September 19, 2007

**Re: GE-Pittsfield/Housatonic River Site  
Groundwater Management Area 5 (GECD350)  
Addendum to Baseline Assessment Final Report and  
Long-Term Monitoring Program Proposal**

GENERAL ELECTRIC COMPANY  
 PITTSFIELD MASSACHUSETTS  
 GMA 5 GROUNDWATER QUALITY  
 MONITORING PROGRAM  
**PROPOSED LONG-TERM  
 GROUNDWATER MONITORING  
 PROGRAM**

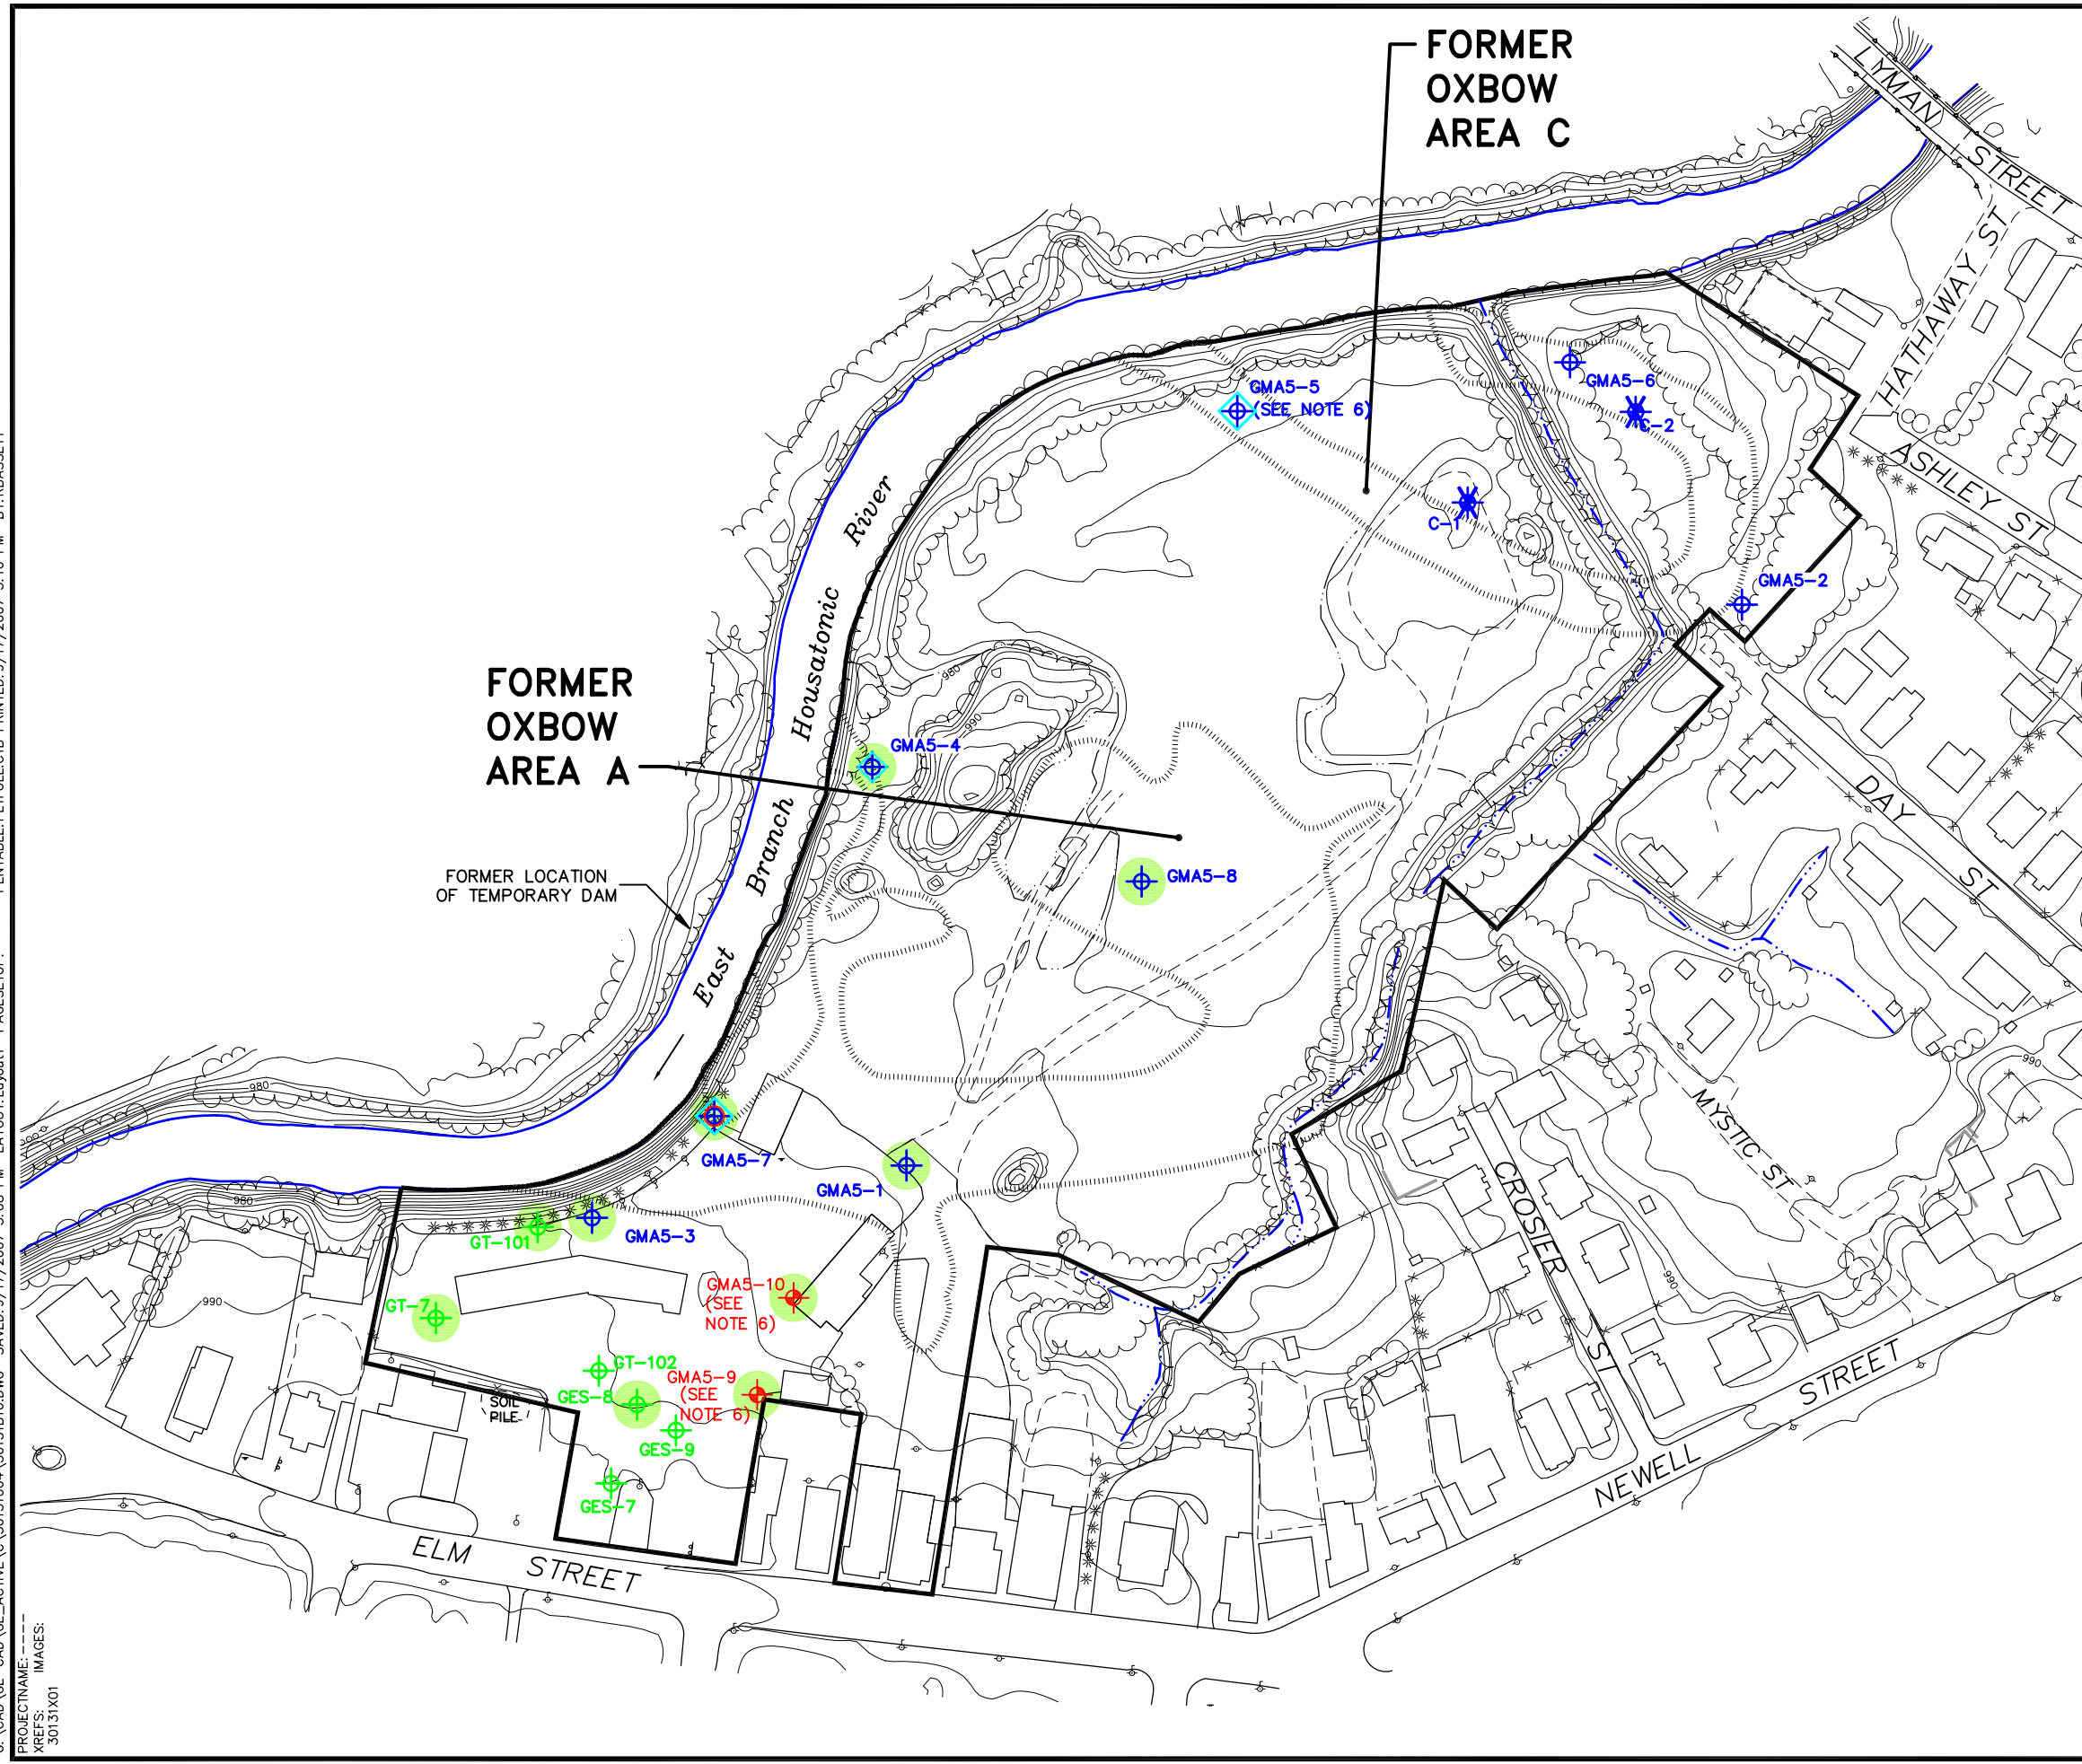
In accordance with Condition 2 of EPA's conditional approval letter, GE has incorporated monitoring wells GT-7 and GT-101 into its proposed semi-annual groundwater elevation and NAPL monitoring network. The entire list of wells subject to groundwater elevation and NAPL monitoring is included in the attached Table 1.

Upon approval by the EPA of this Addendum, GE will immediately begin implementation of the long-term groundwater quality monitoring program at GMA 5, starting with the installation and development of new wells GMA5-9 and GMA5-10 as soon as property access and drilling arrangements can be made.

FIGURE  
**2**

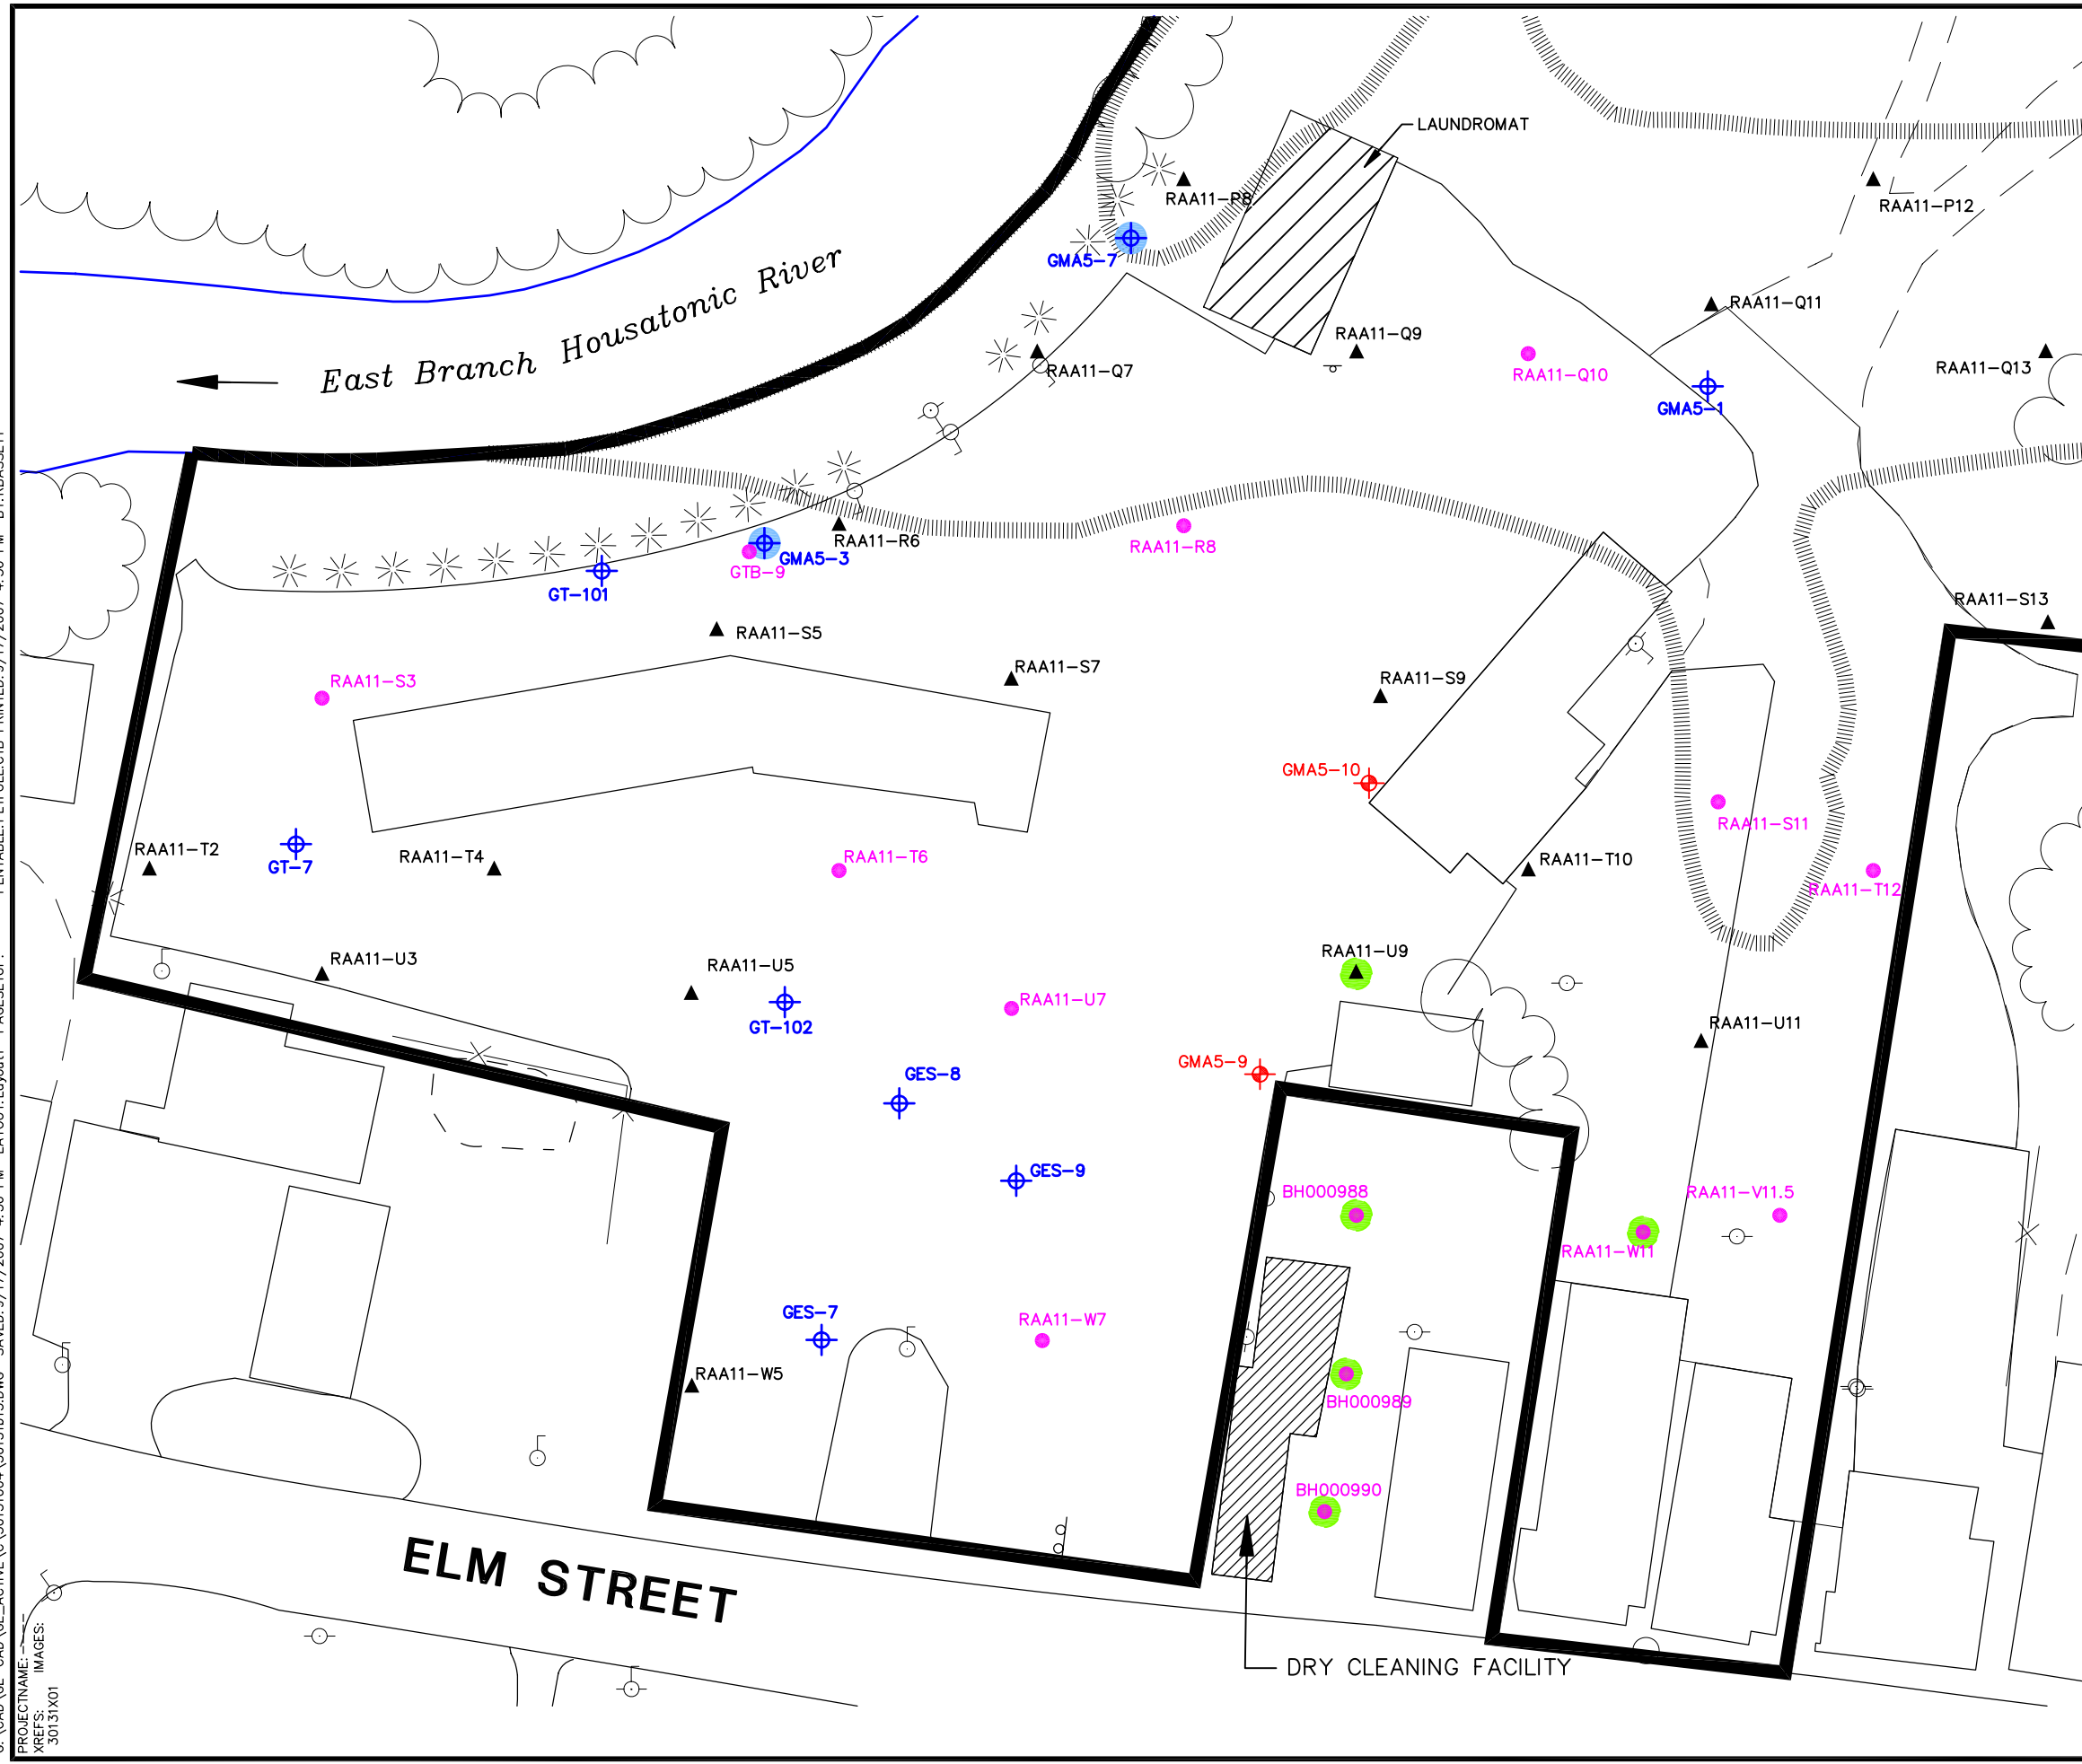
Figure 2, which shows that the detections of PCE in soil are limited to the immediate vicinity of the dry cleaning facility located upgradient of well GMA5-7.

As such, and given the general absence of PCE elsewhere in the GMA, GE believes it is highly unlikely that any PCE found in this well is related to former GE operations at the Site. Nonetheless, in Section 6.2.1 of the GMA 5 Long-Term Monitoring Proposal, GE proposed to sample this well during the long-term monitoring program to confirm that the GW-2 Performance Standard for PCE has been attained. In addition, in accordance with Condition 3 of EPA's conditional approval letter, GE proposes to install two new monitoring wells (identified as GMA5-9 and GMA5-10), at the locations shown on Figure 2, to establish the source of the PCE detections in well GMA5-7.

As shown on Figure 2, the proposed monitoring wells are to be installed between the historical detections of PCE in soil samples at and adjacent to the Former Oxbow Area A RAA (which are all located near the off-site dry cleaning facility) and existing well GMA5-7. Groundwater generally flows from the vicinity of the dry cleaning facility northward toward the Housatonic River, such that constituents in groundwater associated with the PCE-impacted soils near the dry cleaning facility could potentially migrate to well GMA5-7. Proposed wells GMA5-9 and GMA5-10 will provide groundwater quality data at two locations downgradient of the dry cleaning facility and upgradient of well GMA5-7 and the laundromat, thus providing the required evaluation of the potential source of PCE found in GMA 5.

Following the installation of the proposed monitoring wells, supplemental groundwater samples from the new wells will be collected and analyzed for VOCs during the fall 2007 long-term sampling event (as presented in Table 4). Based upon the results of that supplemental sampling, GE will evaluate whether it would be appropriate to include well GMA5-9 and/or GMA5-10 in the long-term groundwater quality monitoring program. Whether or not groundwater quality sampling continues in these wells; however, GE proposes to collect groundwater elevation data from wells GMA5-9 and GMA5-10 during the semi-annual monitoring events performed at GMA 5 during the long-term monitoring program to provide additional monitoring points to further delineate groundwater flow patterns in this area.
